Product Change Notification

1. ECR #: 213435
Notification #: 634

- ISDE - 0.8MM SESD BODY
- SESDT - 0.80MM SOCKET DISCRETE WIRE ASSEMBLY

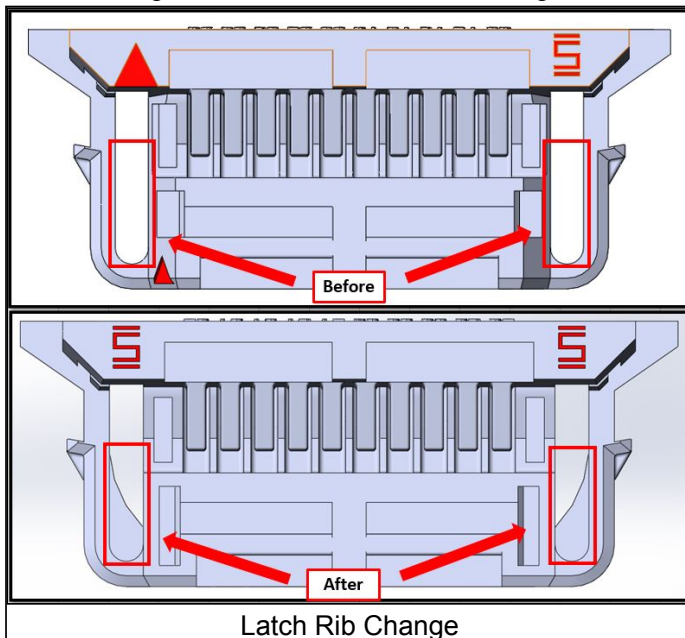
Adding ribs underneath both latch arms.

- Form - Visual change with adding ribs underneath the latch arm.

Improve latching action by updating latch geometry to current design standard. This will not be a rolling change and only new revision bodies will be received after this change is complete.
